DART AEROSPACE LTD		Work Order:	132354
Description: Crosstube Assembly, Mid Aft		Part Number:	D206-667-247
Inspection Dwg: D206-667-247 Rev: A		Page 1 of 2

DRAWING NO. D206-667-247	TITLE GROSSTUBE ASS'Y (206L MID AFT)	REV. A	DART AEROSPACE LTD ENGINEERING ORDER		D.E.O. NO. D206-667-247-A-1	SHEET NO. SHEET 1 OF 1	SCALE NTS
DRAWN <i>JP</i>	CHECKED <i>ASS</i>	MFG. APPR. <i>KB</i>	APPROVED <i>AMP</i>		DE APPR. <i>#</i>		
DATE 11.07.15	DATE 11.07.20	DATE 11.07.21	DATE 11/07/21		DATE 11.7.21

PURPOSE:

REPLACE MAGNOBOND WITH PROSEAL.

D206-667-247
ASSEMBLY DETAIL
(VIEW LOOKING FWD)

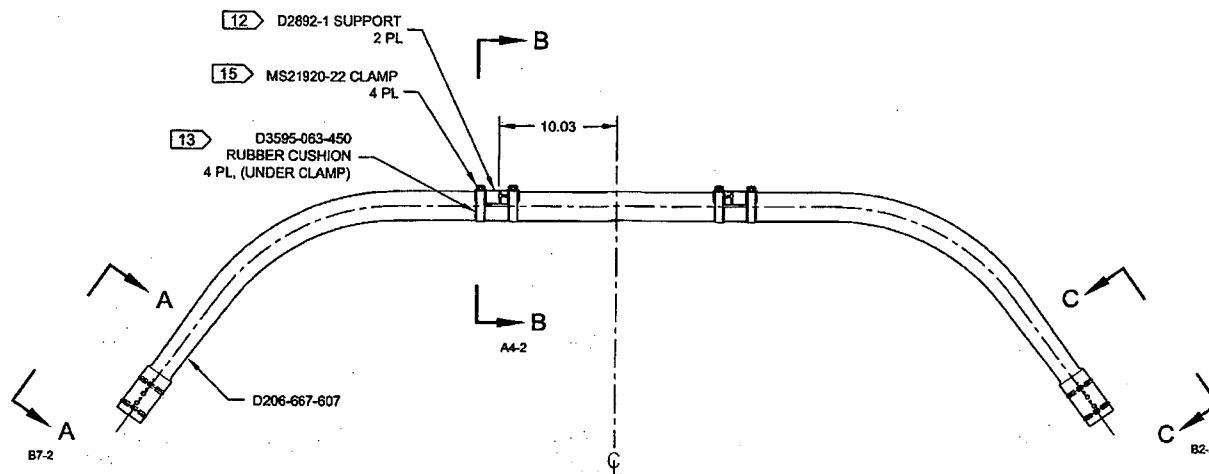
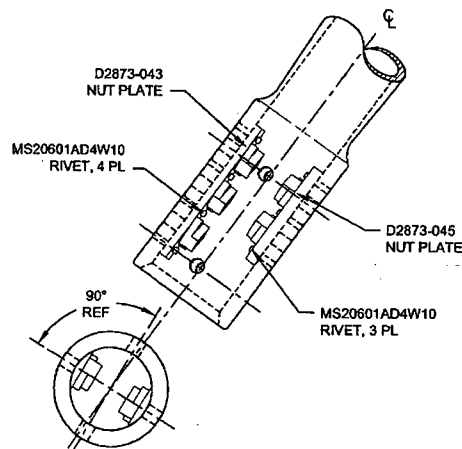
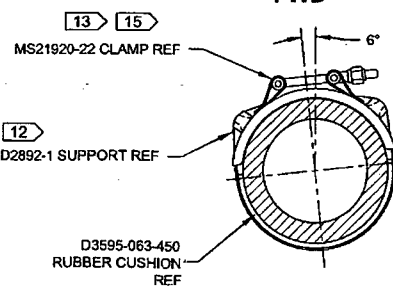
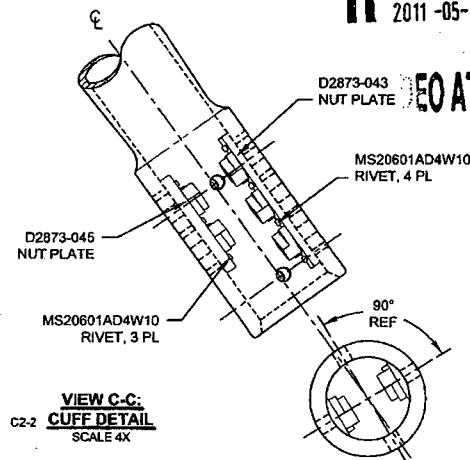
NOTE 12 & 15, SHEET 1 IS AMENDED AS FOLLOWS:

- 12) TO INSTALL D2892-1 SUPPORT: ABRABE MATING SURFACE OF SUPPORT AND CROSSTUBE WITH 180-GRIT SANDPAPER AND REMOVE RESIDUE WITH MEK (OR EQUIVALENT). APPLY A 0.04" TO 0.07" THICK LAYER OF PROSEAL 890 CLASS B-2 (OR AMS-S-8802 CLASS B-2) SEALANT TO MATING SURFACE OF SUPPORT.
- 15) TORQUE CLAMPS 80 TO 100 IN-LB. ENSURE AT LEAST 1.5 THREADS SHOWING IN SAFETY AND THAT NUT HAS NOT BOTTOMED-OUT AFTER TORQUING. **PRIOR TO PACKAGING, RE-CHECK TORQUE ON CLAMPS AFTER PROSEAL 890 SEALANT HAS CURED FOR 72 HOURS.**

- 12) INSTALL D2892-1 SUPPORT USING 0.03" TO 0.06" THICK LAYER OF MAGNOBOND 6398 PER QSI 015. LET CURE FOR 12 HOURS AFTER INSTALLATION AND PRIOR TO PACKAGING.
- 15) TORQUE CLAMPS 80 TO 100 IN-LB. ENSURE AT LEAST 1.5 THREADS SHOWING IN SAFETY AND THAT NUT HAS NOT BOTTOMED-OUT AFTER TORQUING.
